Technical Bulletin

Bulletin No: TCH-022-003

Subject: IMPROVED PARTS IDENTIFICATION FOR BENDIX® RSD REPLACEMENT CAMSHAFTS

Figure 1 – S-Cam Part Number Location

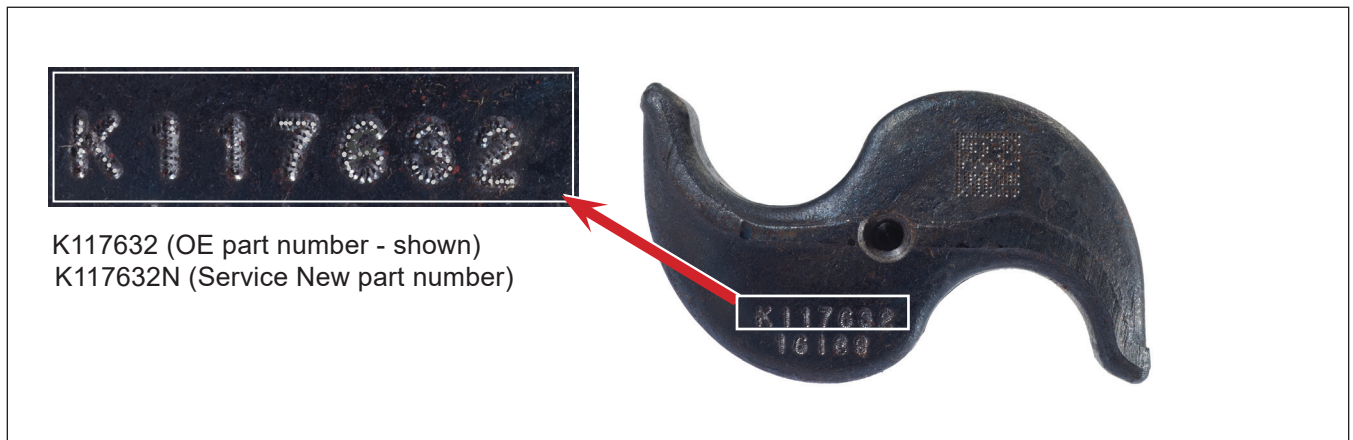
To make it easier for drum brake customers to identify the correct service replacement camshaft, Bendix is now stamping the camshaft part number on the head. This process is done in production for both 10- and 28-tooth camshafts. See Figure 1.

The suffix “N” on the part number denotes that this is a service new part. Part numbers ending in even numbers (e.g. K117632N) are for the left hand camshafts (rotation is counterclockwise), and those ending in odd numbers (e.g. K117633N) are for the right hand camshafts (rotation is clockwise). See Figure 2.

Also, to ensure the camshaft is a genuine Bendix® part, “BENDIX” is now stamped on the inside of the cam head. See Figure 3.
